The Commission has issued the enclosed Amendments Nos. 45 and 45 to Facility Operating Licenses Nos. DPR-44 and DPR-56 for the Peach Bottom Atomic Power Station Units Nos. 2 and 3. The amendments revise the Technical Specifications in response to your request of July 16, 1976, as supplemented April 18 and August 29, 1977, March 27 and April 26, 1978.

These amendments revise the Technical Specifications to modify the reactor coolant system thermal and pressurization limitations to account for neutron irradiation induced increases in reactor vessel metal nil ductility temperature.

PEACH BOTTOM ATOMIC POWER STATION, UNIT NO. 2

AMENDMENT TO FACILITY OPERATING LICENSE

Figure 3.6.1

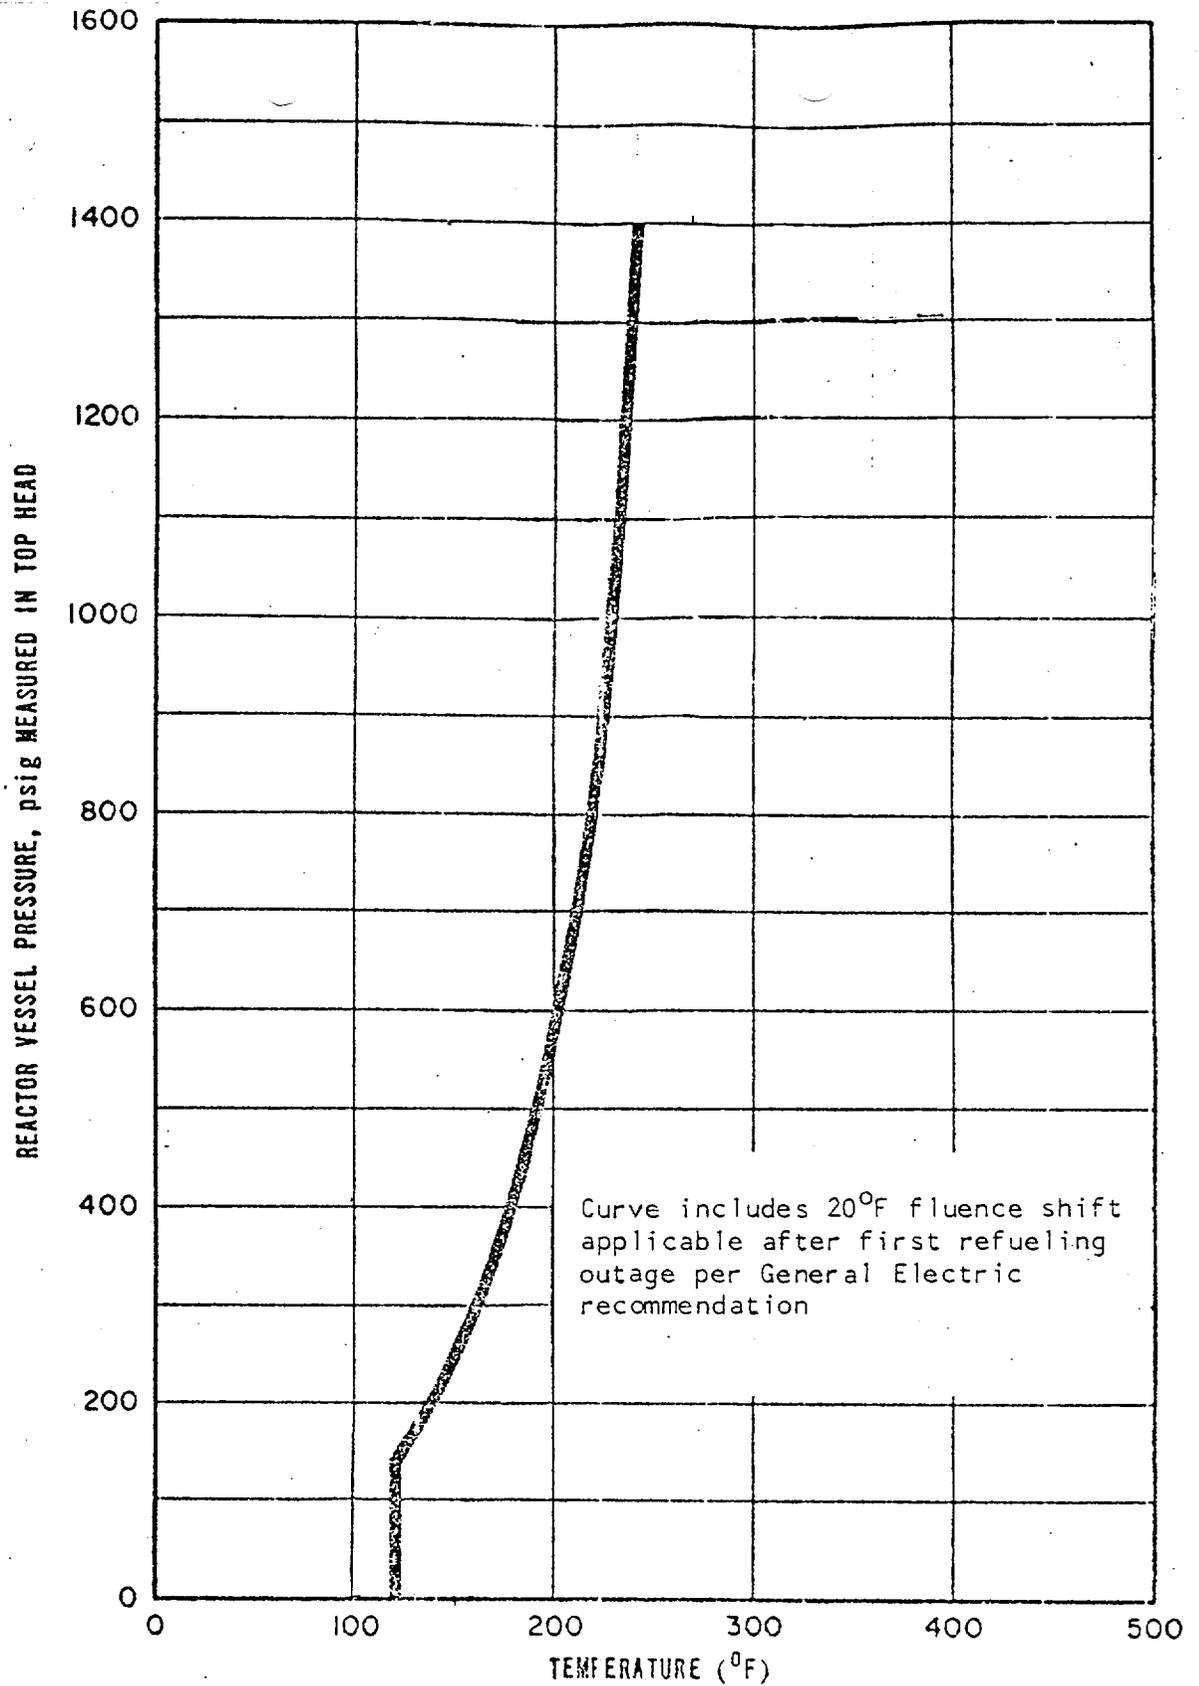
1. The average rate of reactor coolant temperature change during normal heatup or cool-down shall not exceed 100°F increase (or decrease) in any one-hour period.
2. The reactor vessel shall not be pressurized for inservice hydrostatic testing above the pressure allowable for a given temperature by Figure 3.6.1.

Figures 3.6.1, 3.6.2, and 3.6.3 will be updated to account for radiation damage prior to 9 effective full power years of operation.

Figure 3.6.2

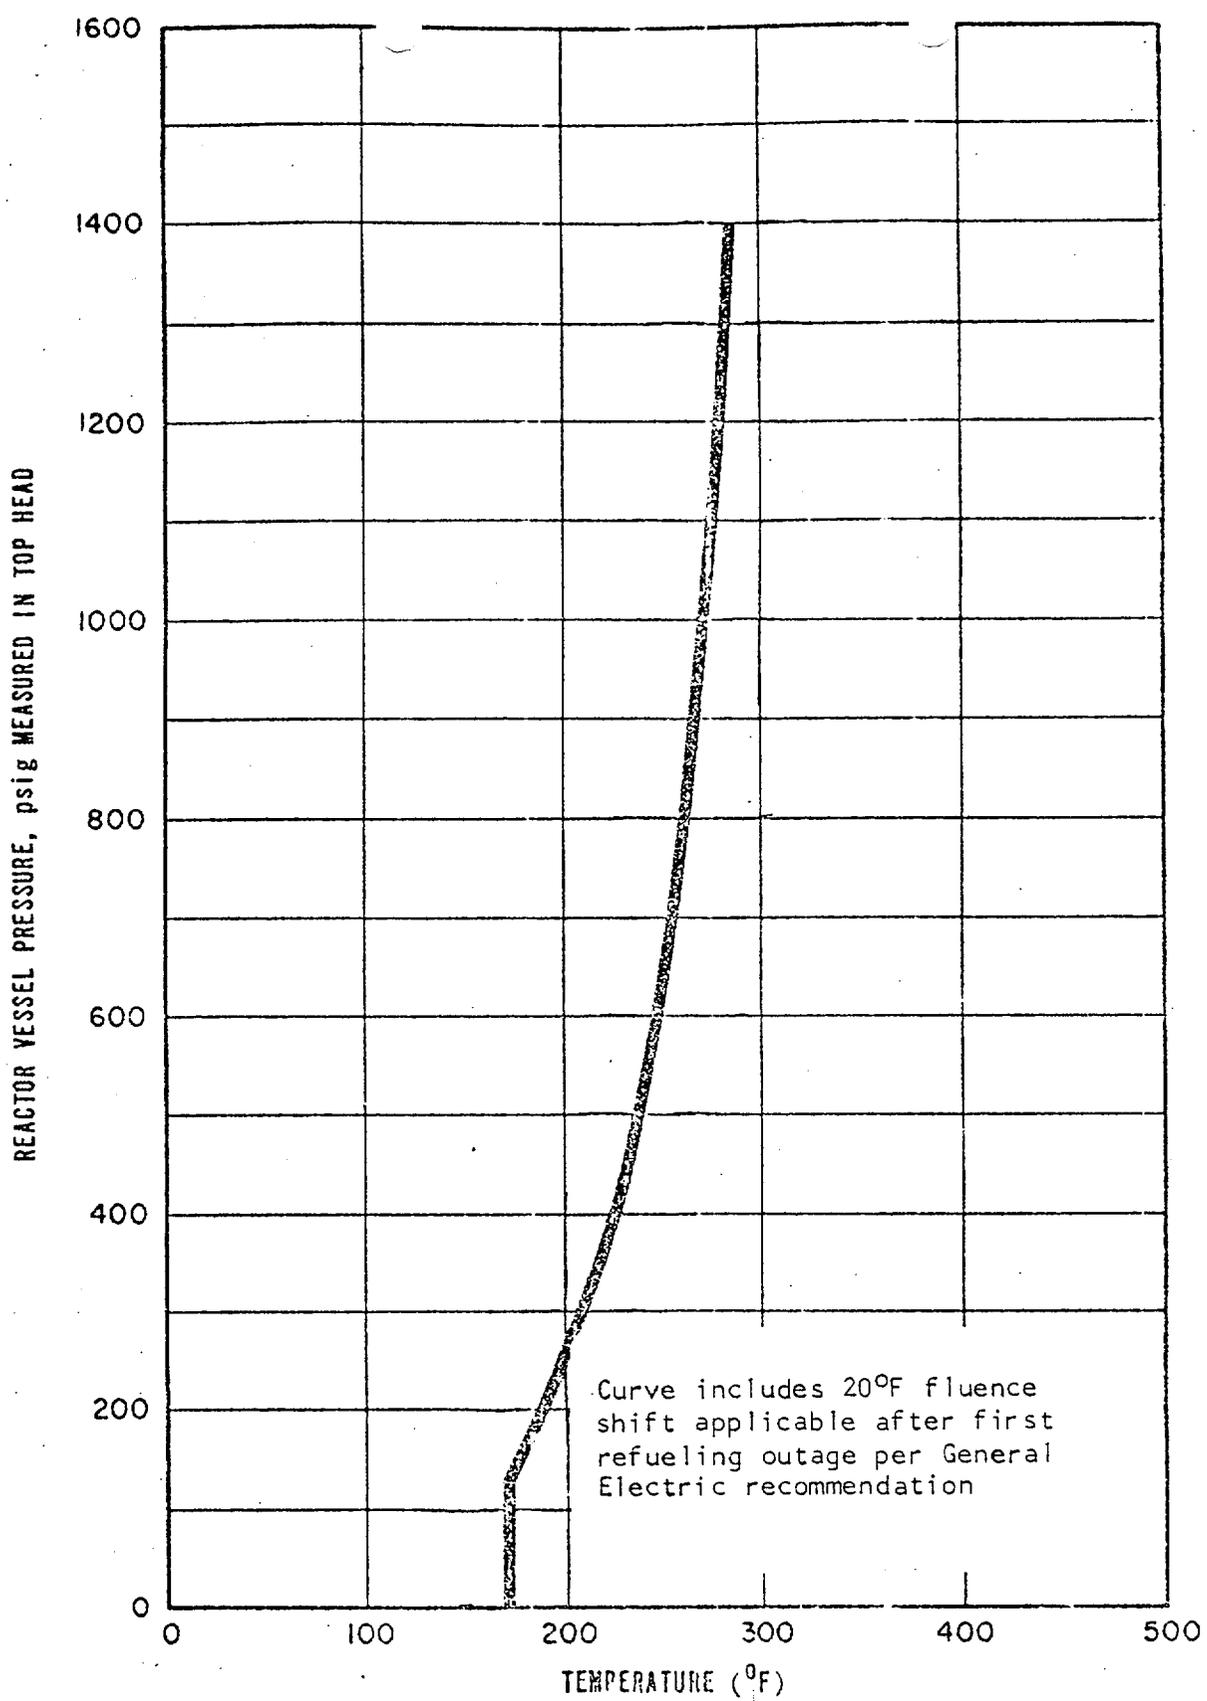
The reactor vessel shall not be pressurized during heatup by non-nuclear means during cooldown following nuclear shut down or during low level physics tests above the pressure allowable by Figure 3.6.2, based on the temperatures recorded under 4.6.A.

Figure 3.6.3

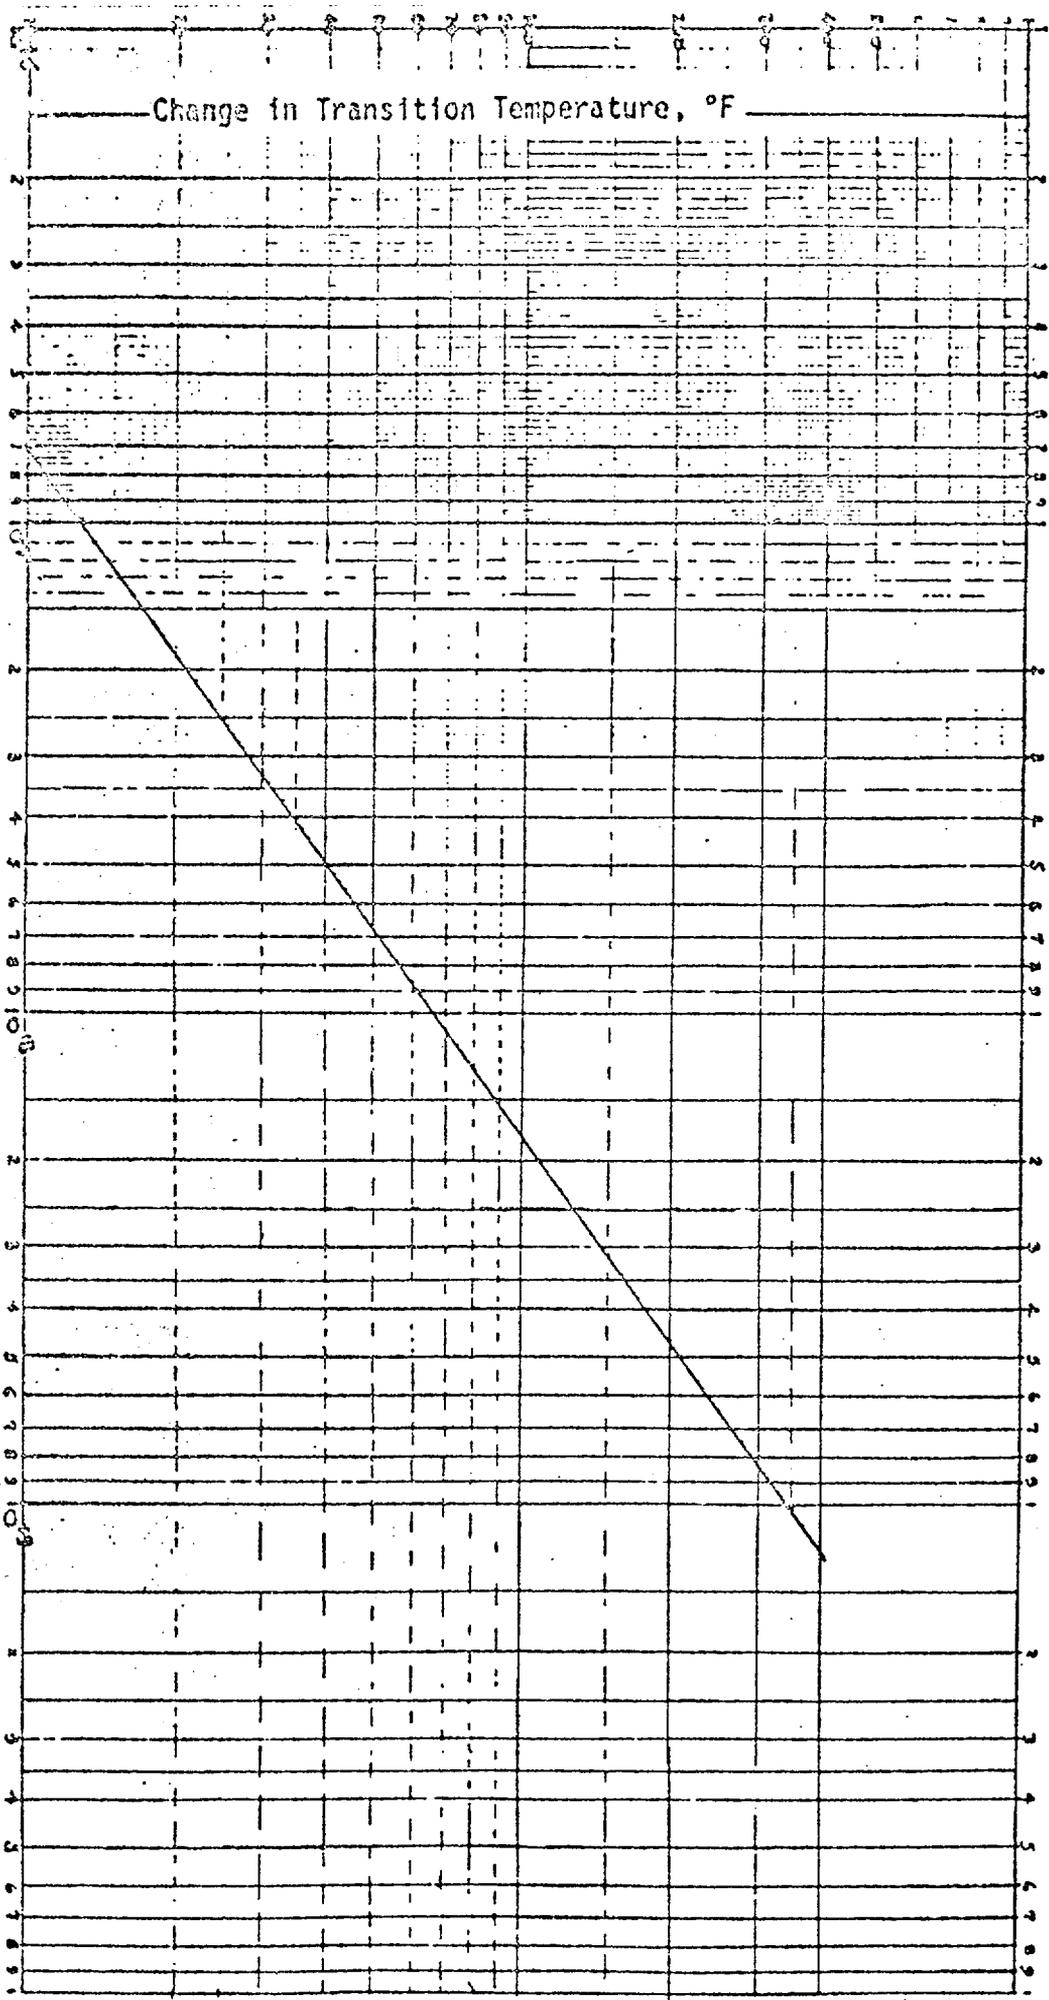
The reactor vessel shall not be pressurized during operation with a critical core above the pressure allowable by Figure 3.6.3, based on the temperatures recorded under 4.6.A.

The vessel pressurization temperatures at any time period can be determined from the thermal power output of the plant and its relation to the neutron fluence and from Figure 3.6.1, 3.6.2, or 3.6.3 in conjunction with Figure 3.6.4. Note: Figure 3.6.3 includes an additional 40°F margin required by 10 CFR 50 Appendix G.

Figure 3.6.1

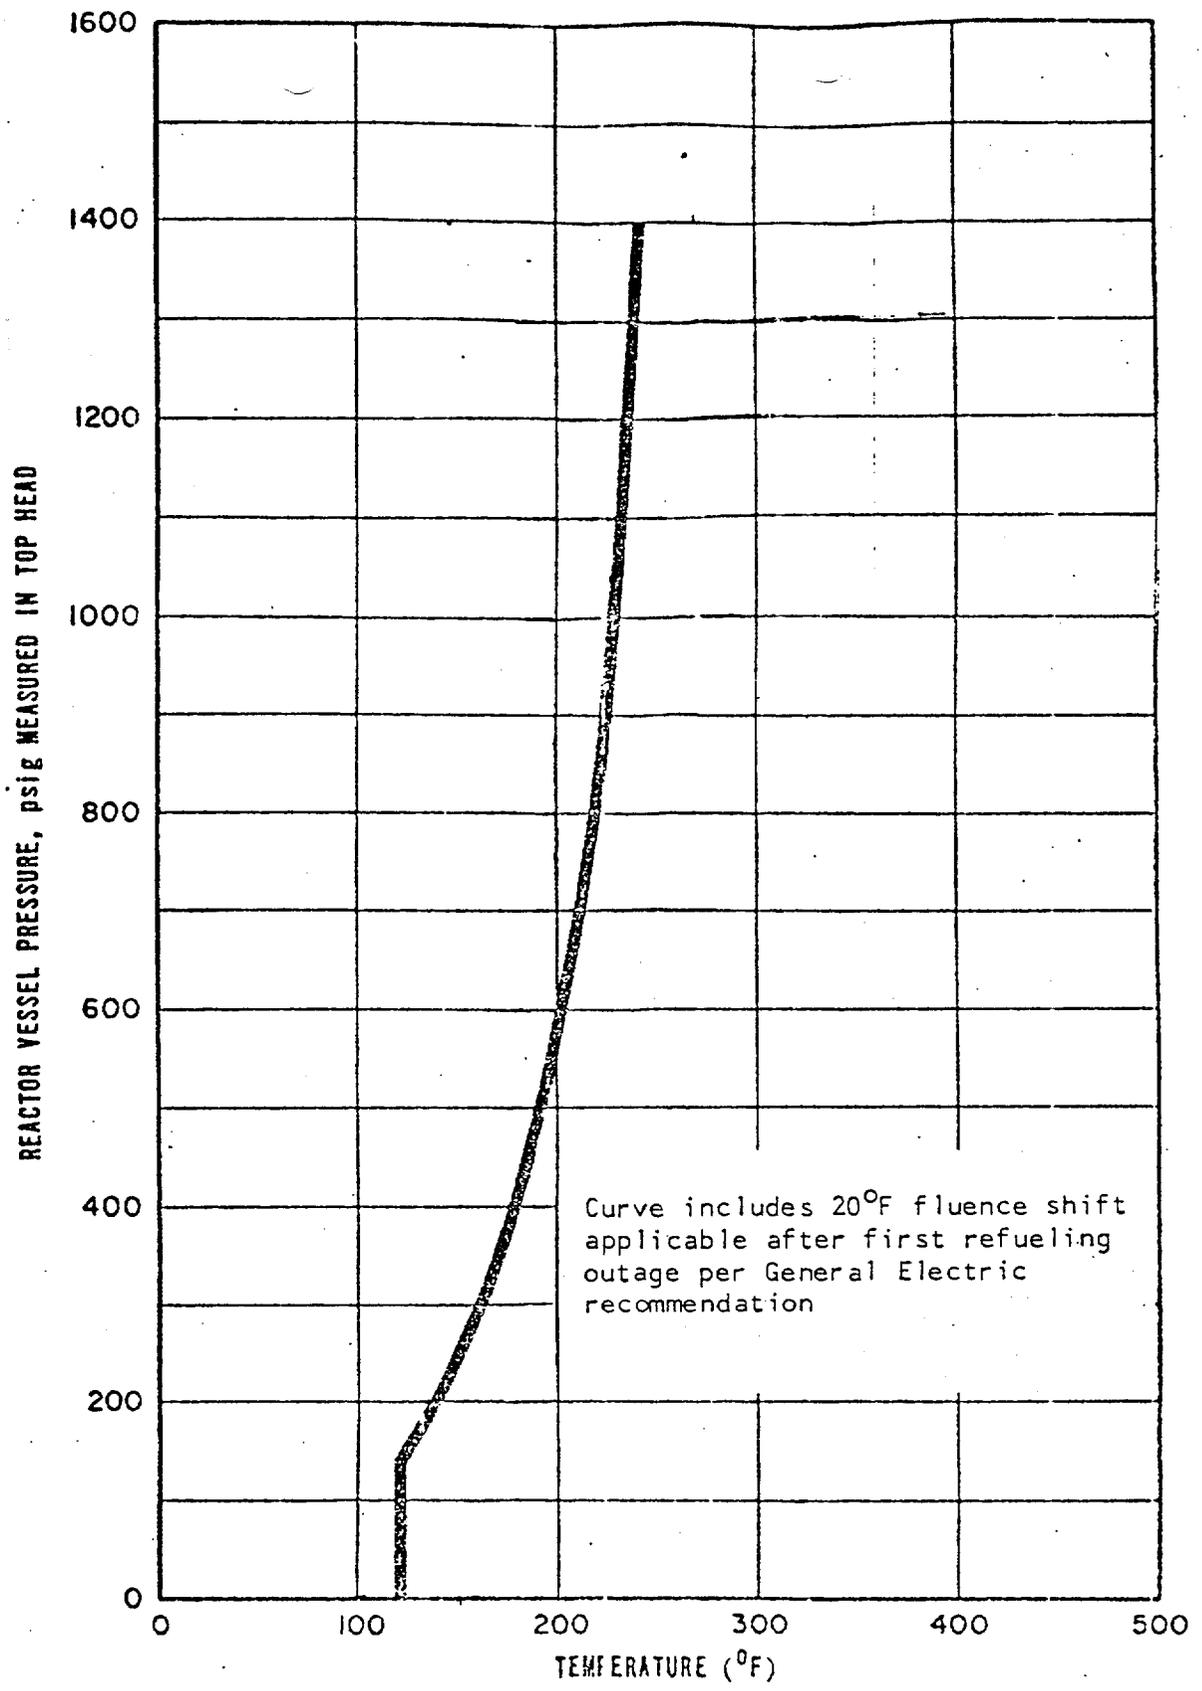
1. The average rate of reactor coolant temperature change during normal heatup or cool-down shall not exceed 100°F increase (or decrease) in any one-hour period.
2. The reactor vessel shall not be pressurized for inservice hydrostatic testing above the pressure allowable for a given temperature by Figure 3.6.1.

Curve includes 20°F fluence shift applicable after first refueling outage per General Electric recommendation

Figure 3.6.2

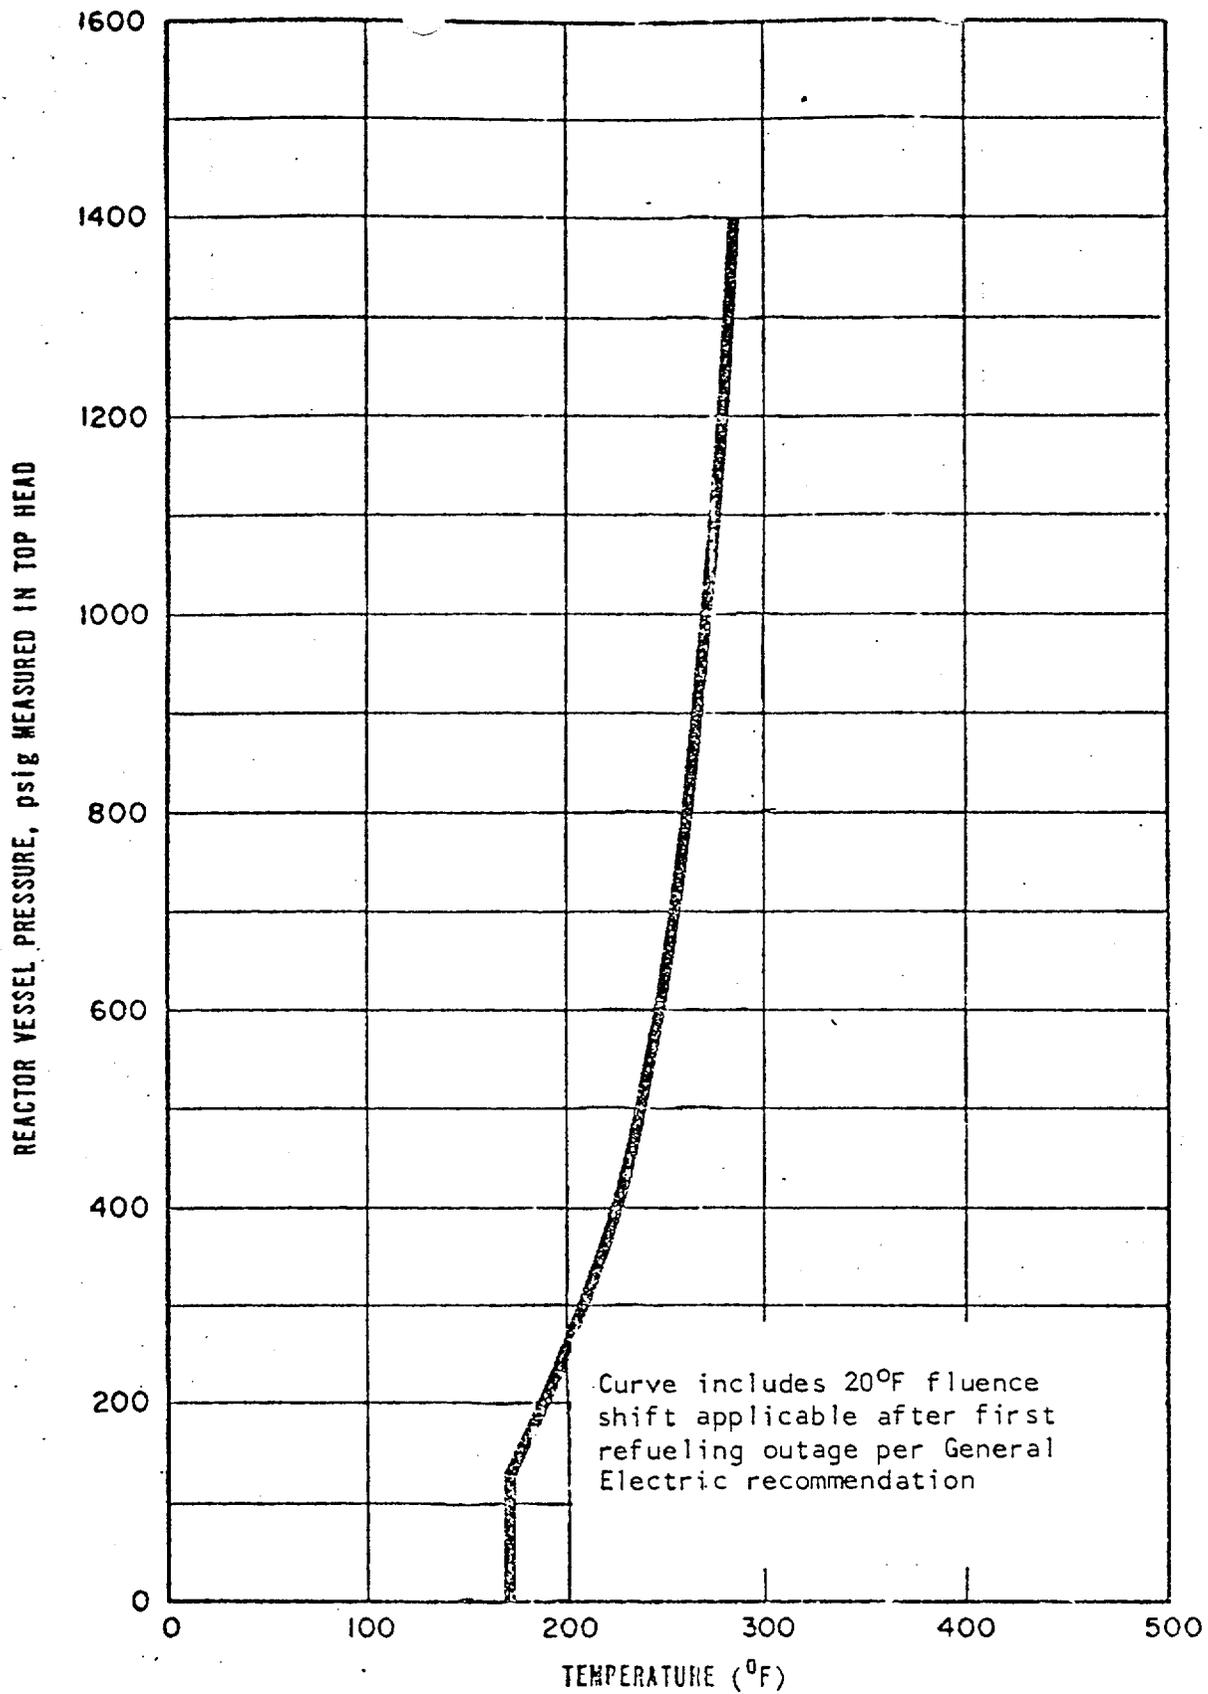
The reactor vessel shall not be pressurized during heatup by non-nuclear means during cooldown following nuclear shut down or during low level physics tests above the pressure allowable by Figure 3.6.2, based on the temperatures recorded under 4.6.A.
